## JOINT REGIONAL PLANNING PANEL Sydney West Region

JRPP No	2015SYW201
DA Number	DA NO. 256/2015/JP/B
Local Government Area	<b>CITY OF PARRAMATTA (THE HILLS SHIRE COUNCIL AT TIME OF LODGEMENT)</b>
Proposed Development	<b>SECTION 96(2) MODIFICATION TO AN APPROVED RESIDENTIAL FLAT BUILDING DEVELOPMENT</b>
Street Address	<b>LOT 2 DP 1158967, LOT 101 DP 617754 - 27-33 NORTH ROCKS ROAD, NORTH ROCKS</b>
Applicant/Owner	<b>SILKY CONSTRUCTIONS</b>
Number of Submissions	<b>NIL</b>
Regional Development Criteria (Schedule 4A of the Act)	Item 3 - General development over \$20 million.
List of All Relevant s79C(1)(a) Matters	<ul style="list-style-type: none"> <li>• List all of the relevant environmental planning instruments: s79C(1)(a)(i): <ul style="list-style-type: none"> <li>- The Hills Local Environmental Plan 2012</li> <li>- State Environmental Planning Policy (State and Regional Development) 2011.</li> <li>- State Environmental Planning Policy No. 65- Design Quality of Residential Apartment Development</li> </ul> </li> <li>• List any proposed instrument that is or has been the subject of public consultation under the Act and that has been notified to the consent authority: s79C(1)(a)(ii)

Figure 7: Minimum setback and separation distances

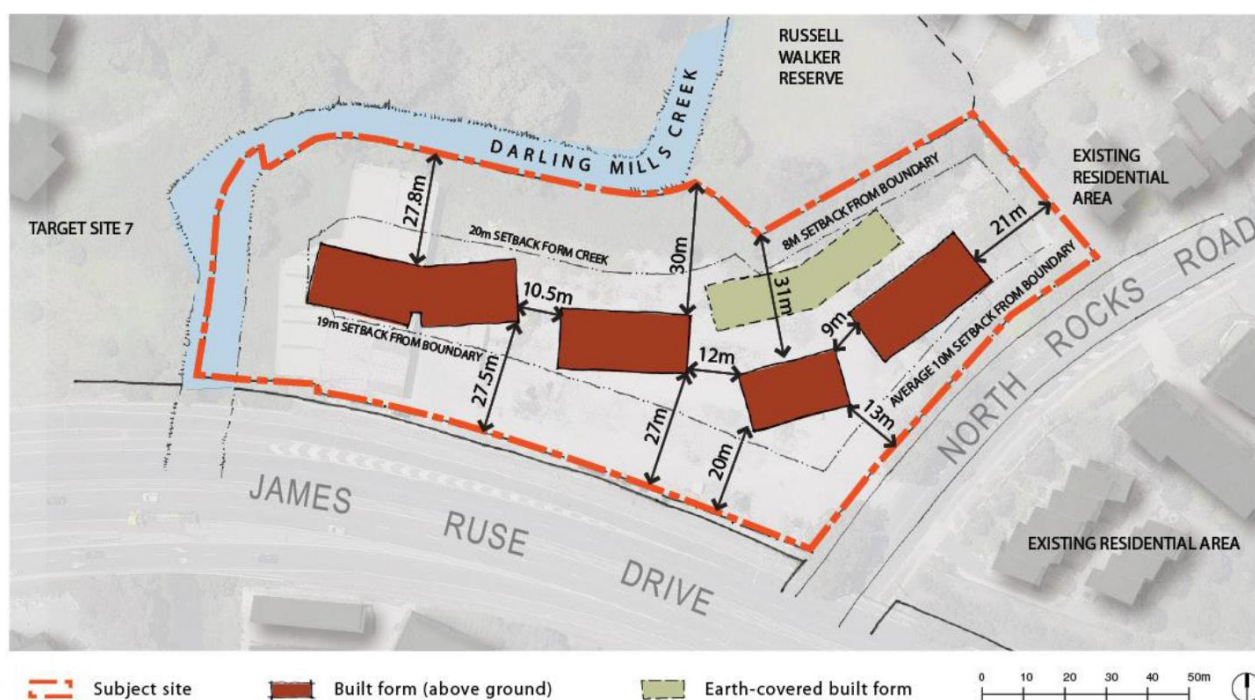
Minor variations are proposed as follows:

- Average setback from North Rocks Road in excess of 10 metres. The setback of Building E varies from 5 metres to 10 metres from North Rocks Road.
- Setback from Russell Walker Reserve is generally in excess of 8 metres. The modification proposal moves both 2 storey terrace units. One set of terraces is moved to the north, resulting in a minor encroachment to the 8 metre setback by about 2 metres. The other set of terraces to the north however does not result in any encroachment into the minimum setbacks;

The development as modified proposes minor variations to the setbacks as illustrated above. It is considered that the proposed setbacks are generally consistent with the envisaged building envelope and setbacks illustrated in Figure 7: Minimum setback and separation distances under The Hills DCP Part D Section 1 – 27-33 North Rocks Road, North Rocks. The proposed development will not adversely impact adjoining neighbours given that the setbacks are towards North Rocks Road, James Ruse Drive, and Darling Mills Creek. It is considered that the development provides adequate solar penetration and view corridors and is a minor variation from the development as approved. In view

of the above, it is considered that the setbacks and building separation of the modified development is supportable.

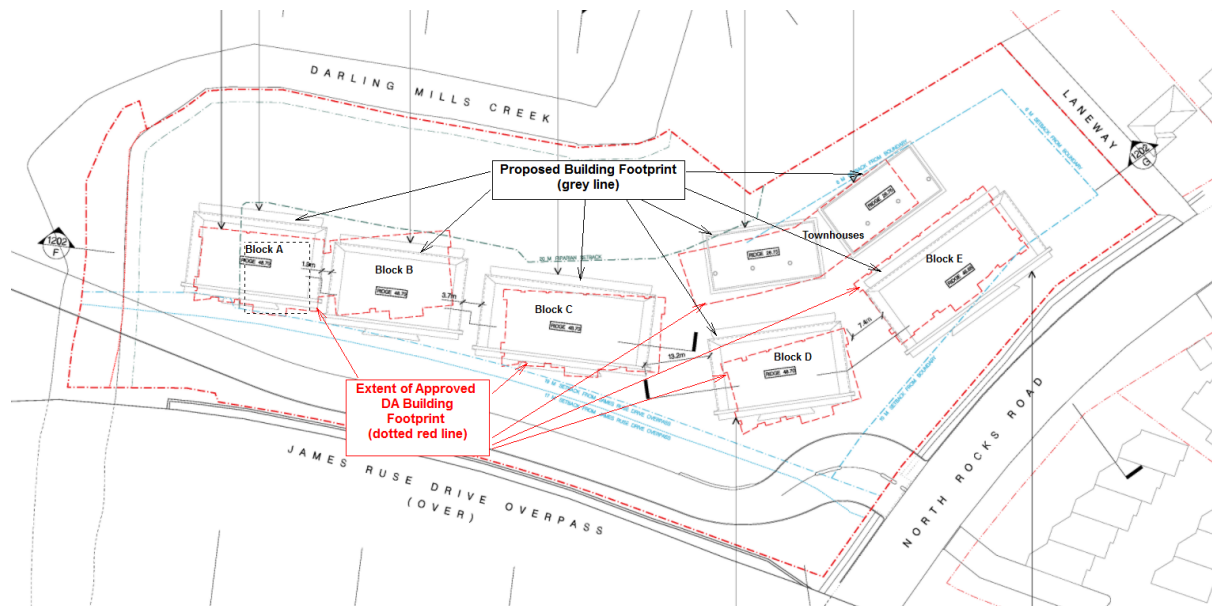
*"Overall, the variations to the setbacks are considered acceptable. Impacts upon neighbouring properties are minor, noting that on the whole the setbacks are consistent with the minimums required and any variations are generally point encroachments."*

Figure 12 below shows the site plan, with the previously approved design and the DCP setbacks. As is shown, the originally approved proposal encroached into the minimum setback areas from James Ruse Drive, North Rocks Road, and Darling Mills Creek. The modified proposal therefore is generally consistent with the requirements, and while setbacks are reduced at some points they are increased in other locations.
